Value Engineering Study Report

Project – CSSTP-0008-00(651)

*Bridge Replacement @ Skidaway Narrows
And*

Widening of SR 204 SPUR/Diamond Causeway

ALTERNATIVE NO.: SNNB-1

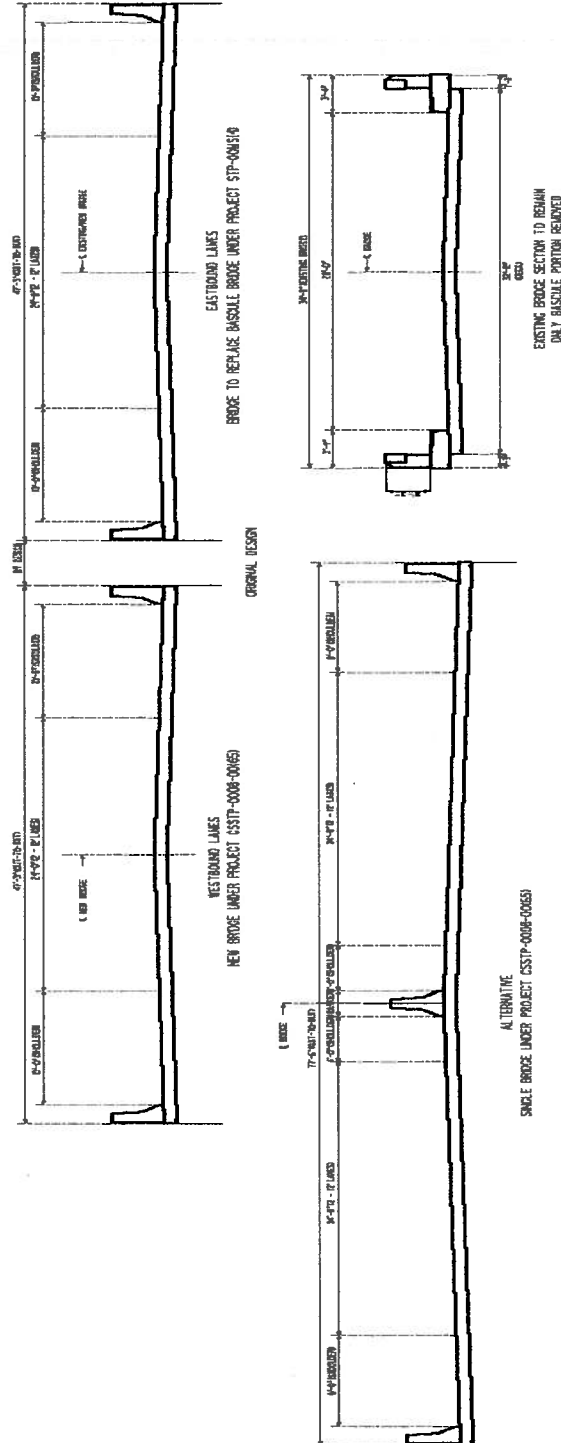
DESCRIPTION: BUILD SINGLE STRUCTURE AS OPPOSED TO DUAL STRUCTURE

The alternative recommends the construction of a single wide bridge to accommodate 4 lanes and carry bi-directional traffic in-lieu of twin structures. Other geometry and components of the project would remain the same as in the original design. Additionally, removal of the existing bridge may be limited to the center span (steel draw bridge portion) only leaving the approach spans in place to serve as a fishing pier.

The single wide bridge may be constructed to accommodate 8' outside shoulders, 4' inside shoulders, 2-12' travel lanes in each direction, a median barrier for positive traffic separation and standard barrier rails for a total width of 77'-6" as opposed to two structures each of 48' width. (Note that Chapter 7 "Rural and Urban Arterials", Section under "Shoulders", page 455 of the AASHTO – Geometric Design of Highways and Streets, allows the use of 8' outside and 4' inside shoulders on "Long Bridges").

DESCRIPTION: **USE 8' SHOULDERS IN-LIEU OF 10' SHOULDERS**

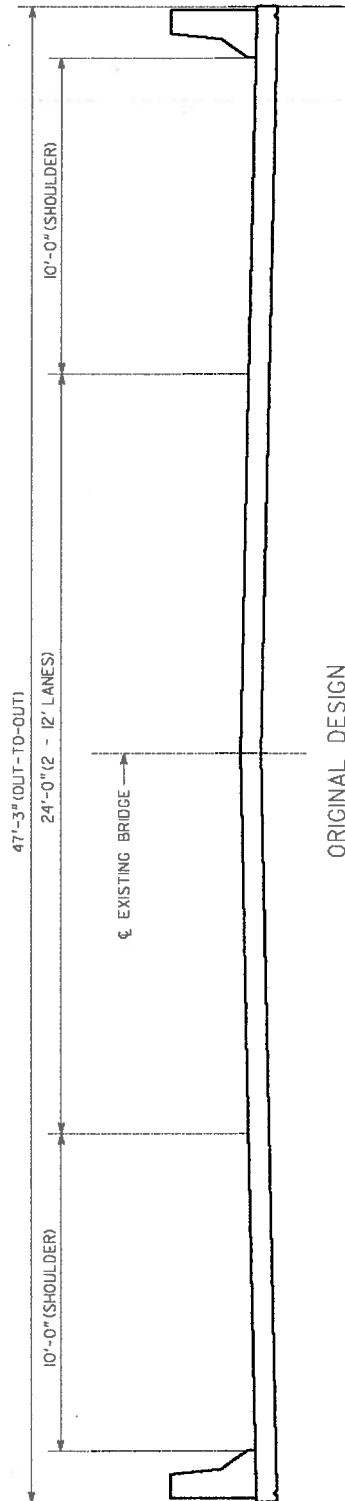
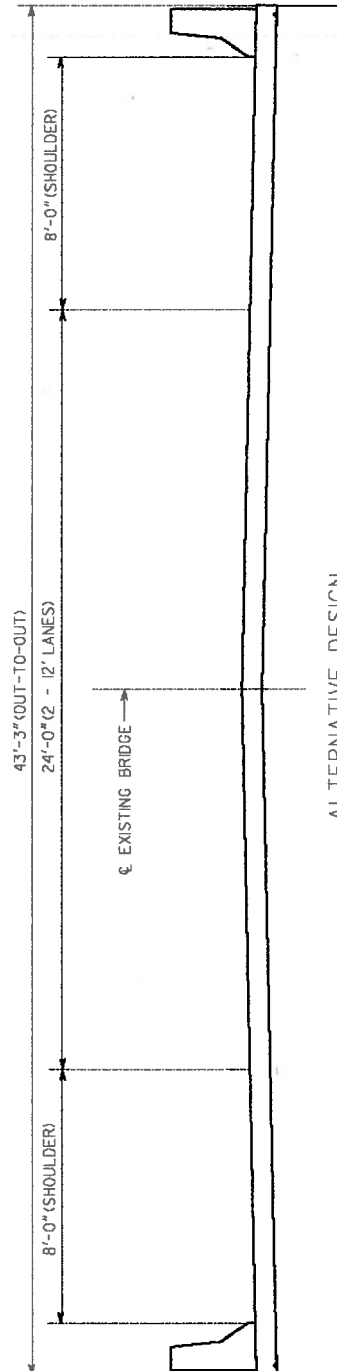
ORIGINAL DESIGN
NEW BRIDGE UNDER PROJECT CSSTP-0008-00(65)

ALTERNATIVE DESIGN
NEW BRIDGE UNDER PROJECT CSSTP-0008-00(65)

ALTERNATIVE NO.:
SNRW-1

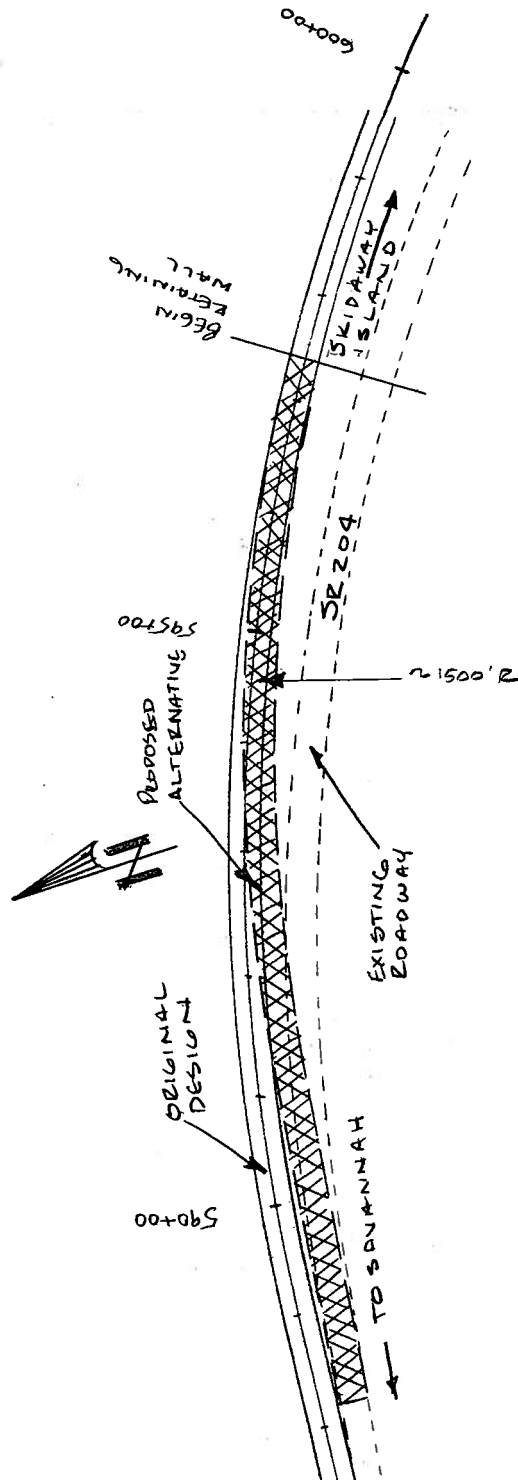
| DESCRIPTION: | MODIFY THE GEOMETRY AT WESTERN TIE (BEGIN PROJECT) TO UTILIZE MORE EXISTING PAVEMENT. | SHEET NO.: 1 of 4 |

By reducing and relocating the crossover/transition at the “Begin Project” you can decrease the amount of paving and the modification.

ALTERNATIVE NO.:
DCRW-2

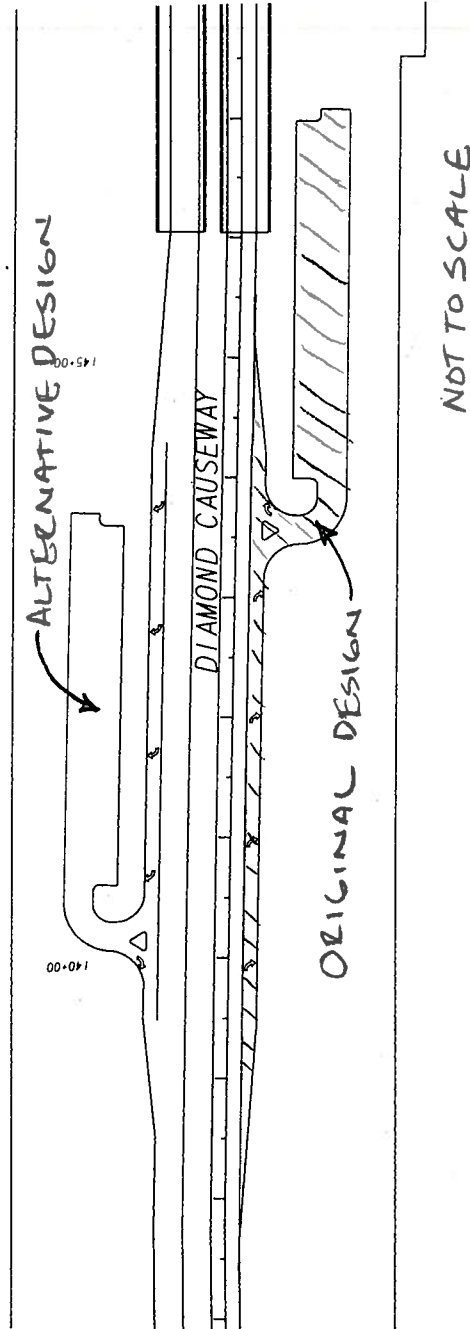
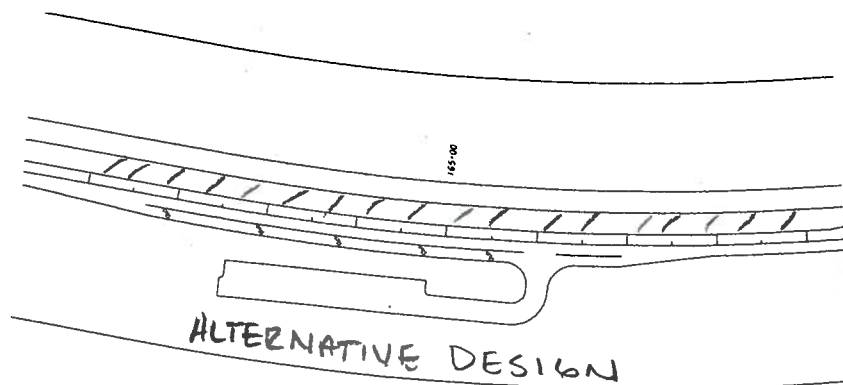
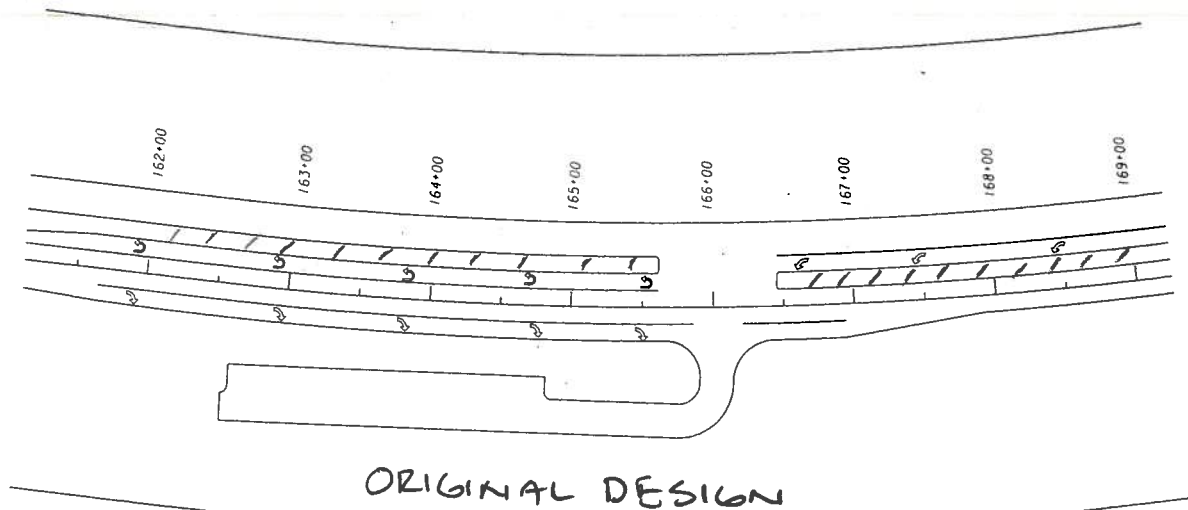
By relocating the western parking area to the north side of the bridge, making the access to both parking areas right-in/right-out and removing the crossover at Station 166+00 you will eliminate the left turn conflict at the cross-over. The proposed crossover is located within 800' of another crossover just to the east.

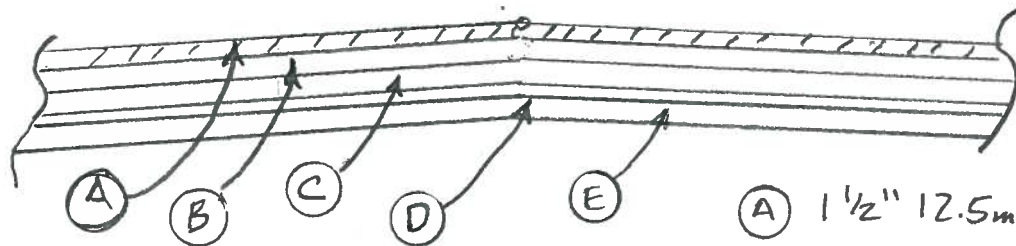
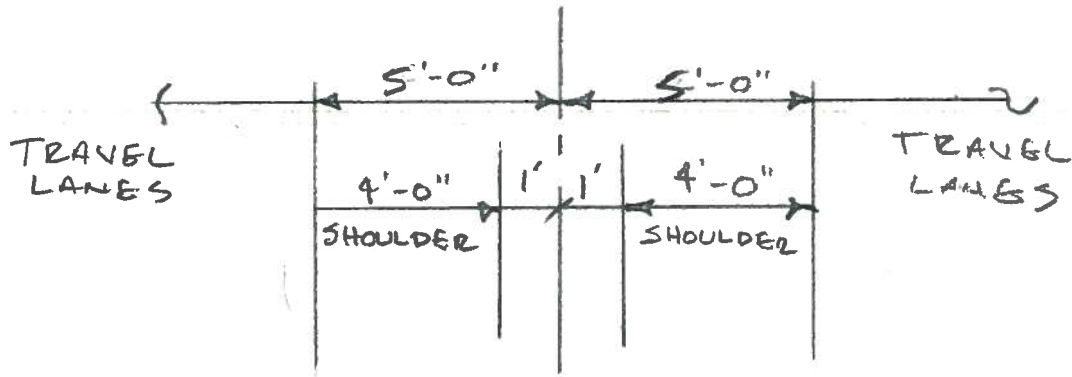
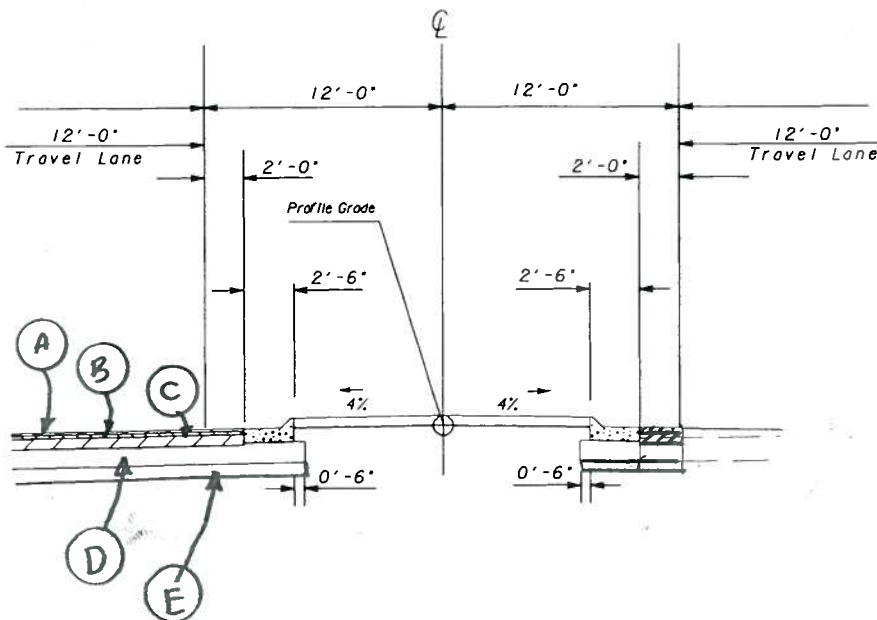
While the cost savings are minimal the wider shoulders, positive barrier, reduced wetland impacts and compatibility with other cost saving proposals provide positive improvements to the project.

ALTERNATIVE DESIGN (MRB-1)

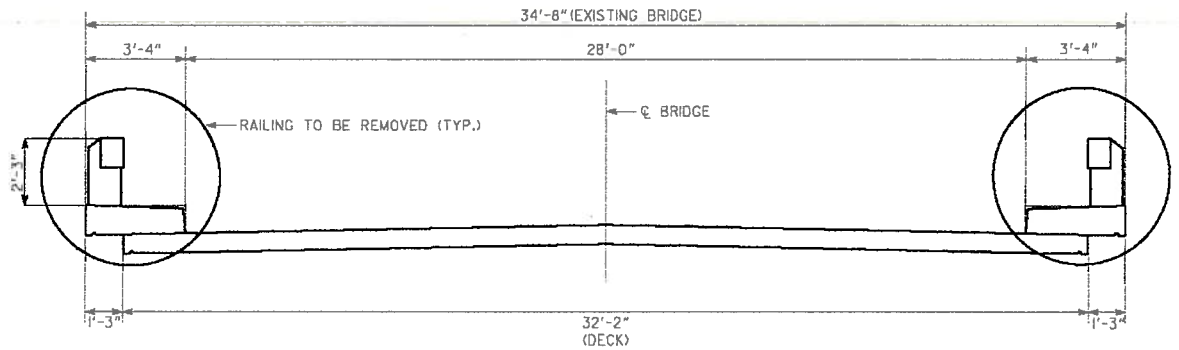
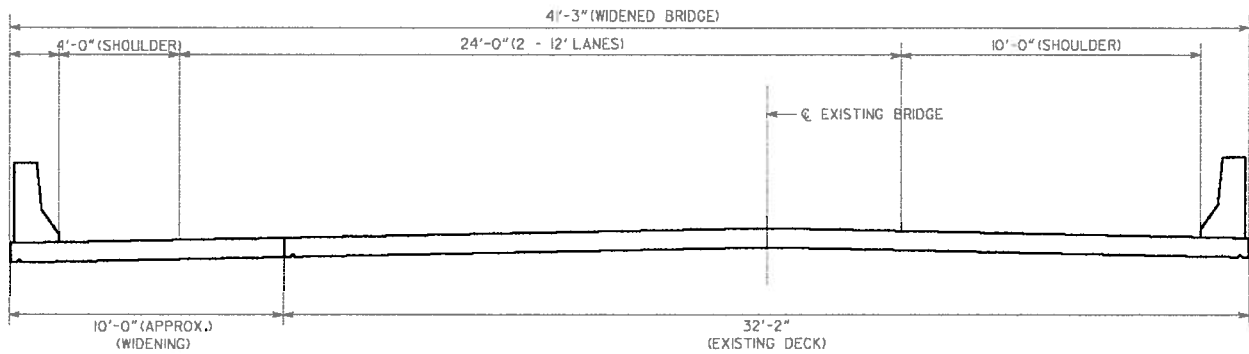
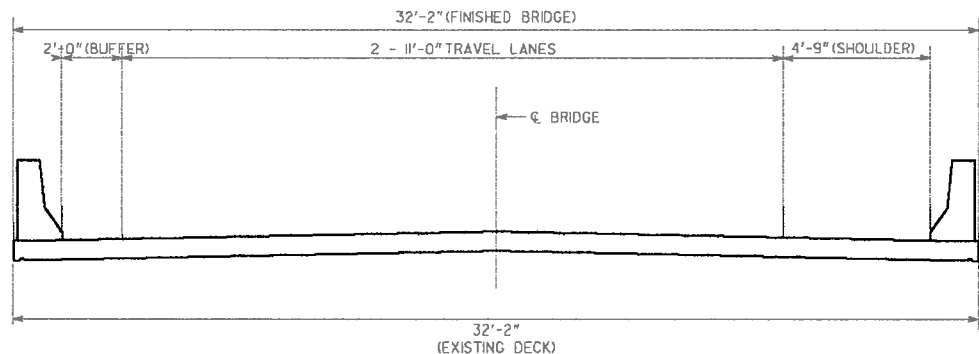
Alternative: The alternative recommends making modifications to the existing deck in-lieu of widening the bridge to serve as the Eastbound Lanes. Other geometry and components of the project would remain the same as in the original design (including constructing a twin bridge to the North to serve as the Westbound Lanes).

This alternative proposes making modifications to the existing deck in-lieu of widening the bridge to serve as the Eastbound Lanes. The only new construction is the addition of standard bridge rails.

| DESCRIPTION: USE 8' OUTSIDE AND 4' INSIDE SHOULDERS IN-LIEU OF 10' SHOULDERS | SHEET NO.: 1 of 4 |

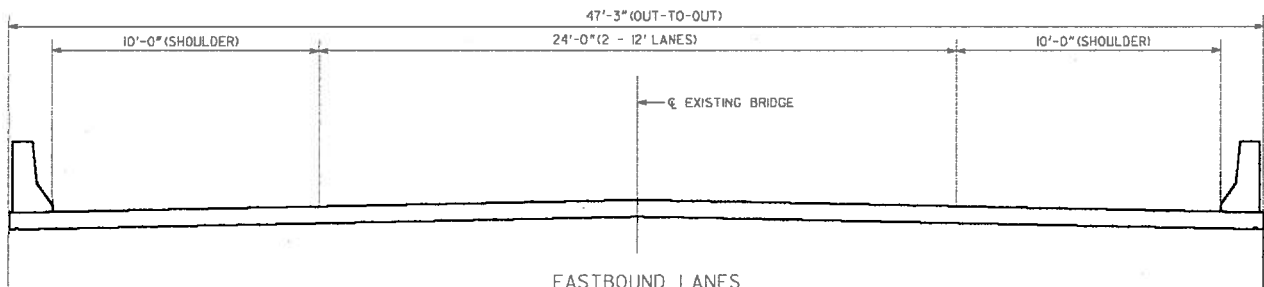
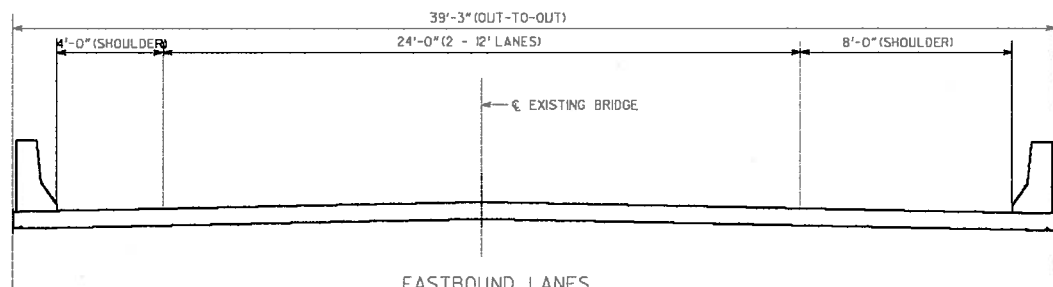
The original design calls for the construction of a 2050' long bridge over Skidaway Narrows to replace the existing Bascule bridge under this contract which follows the construction of an identical twin bridge under contract CSSTP-0008-00(65). The bridge is 47'-3" wide and accommodates 2-12 ft travel lanes, 2-10' bike able shoulders and standard barriers.
